Job Title :-
PROPOSED ADDITIONS TO PREVIOUSLY APPROVED PLAN No. AU 629 ON LR. No. 1 / 862 , MARCUS GARVEY RD, NAIROBI.

Sheet title :-
**TYPICAL OFFICE FLOORS,
6th - 13th FLOORS**

job no. J 198	drg no. L12-111
---------------	-----------------

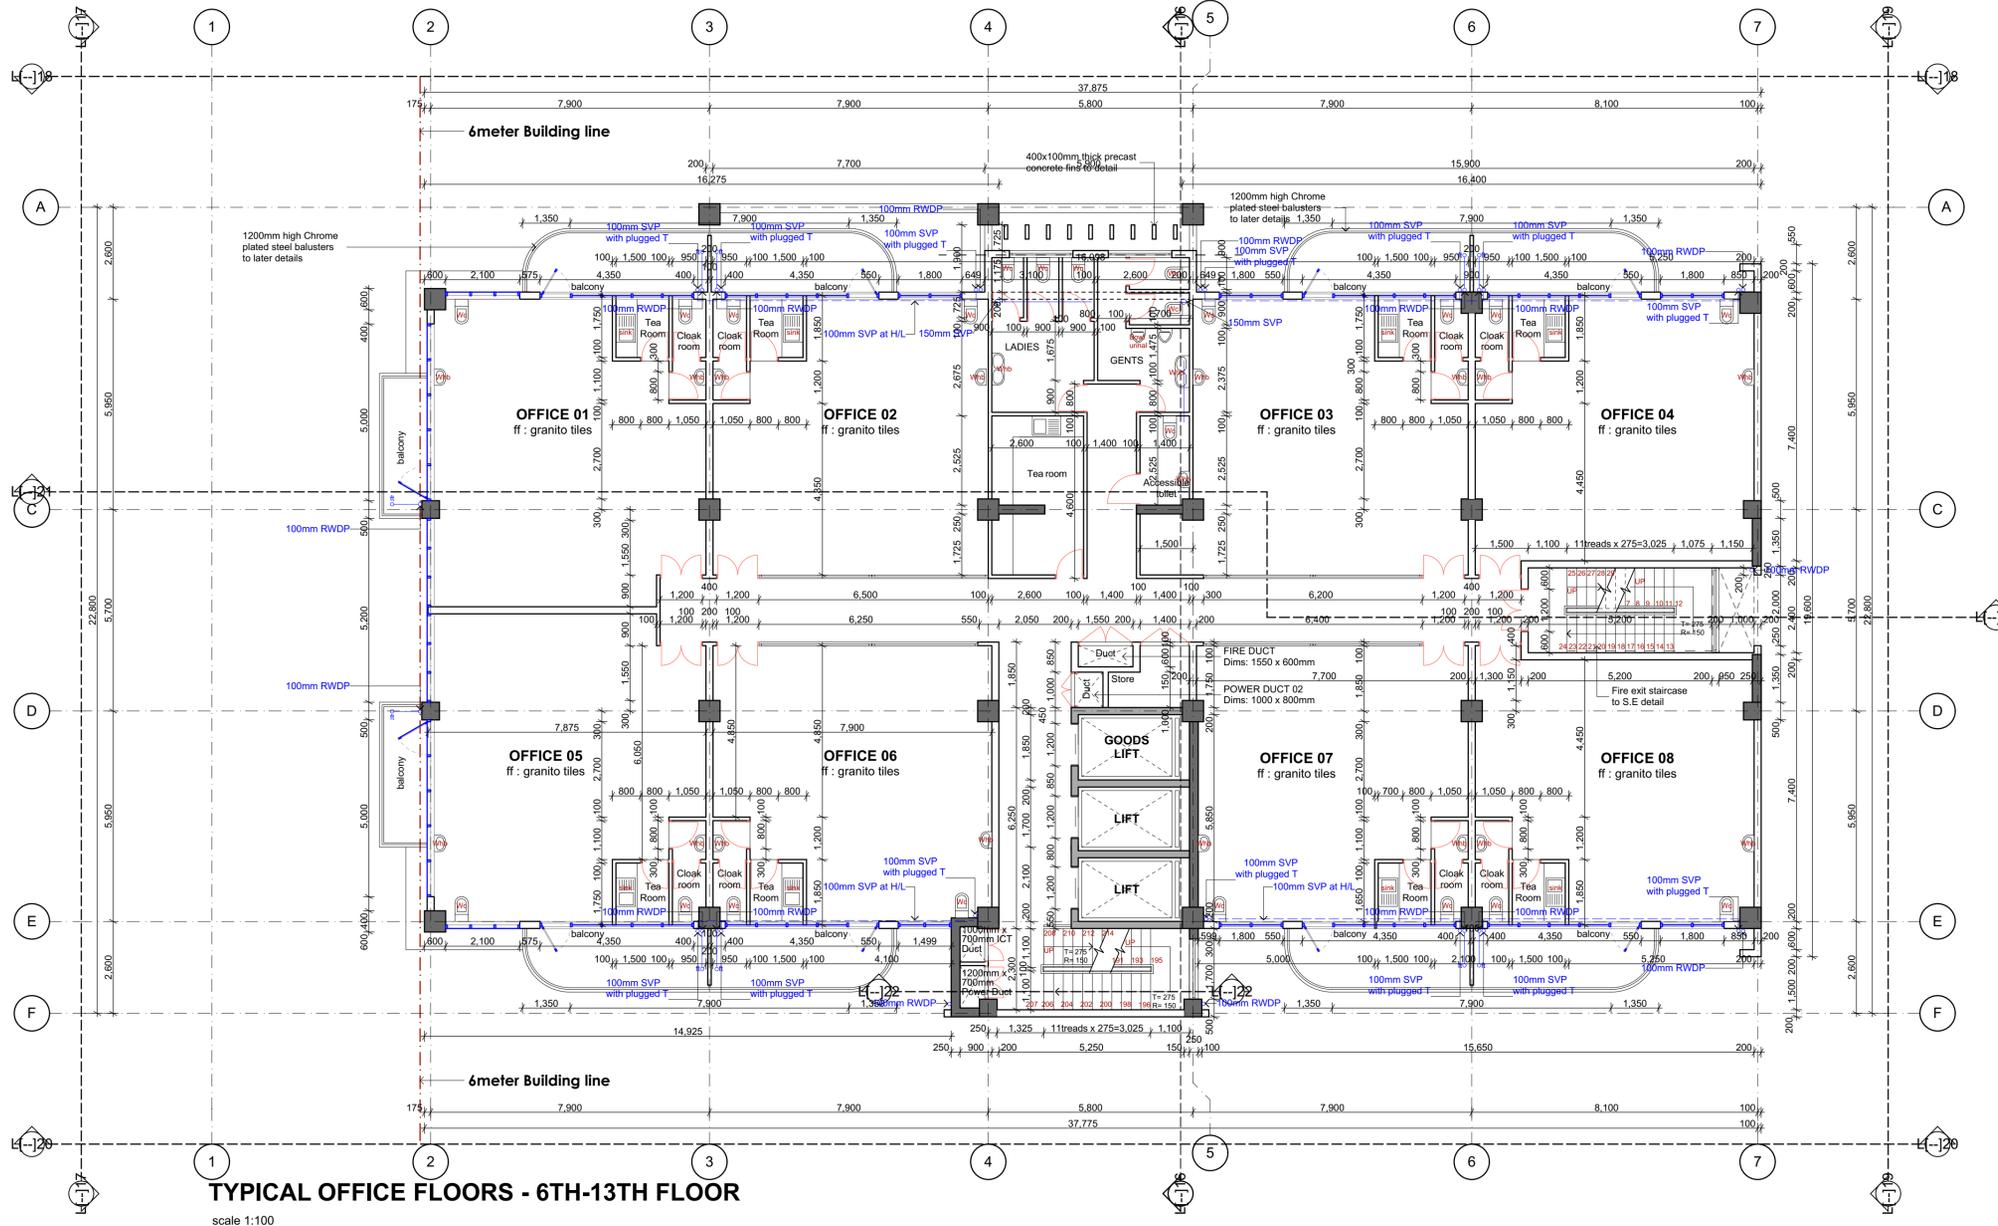
NO.	DATE	DETAILS
E	05.01.2023	1. balconies along grids 'E' & 'E', depth revised from 1350mm to 1800mm 2. office space & washrooms amended from 10th to terrace floors. 3. washroom layouts amended to 4th to 9th floors.
F	10.05.2023	1. common washrooms extended to beam 1250mm from grid line 'B'. 2. kitchen & accessible washroom amended. 3. 13th typical office floor added. 4. previous 14th-15 floors floor heights amended from 3900mm to 3600mm. 5. external window sill heights amended from 1000mm to 450mm high. 6. window openings to office tea room & cloaks amended.
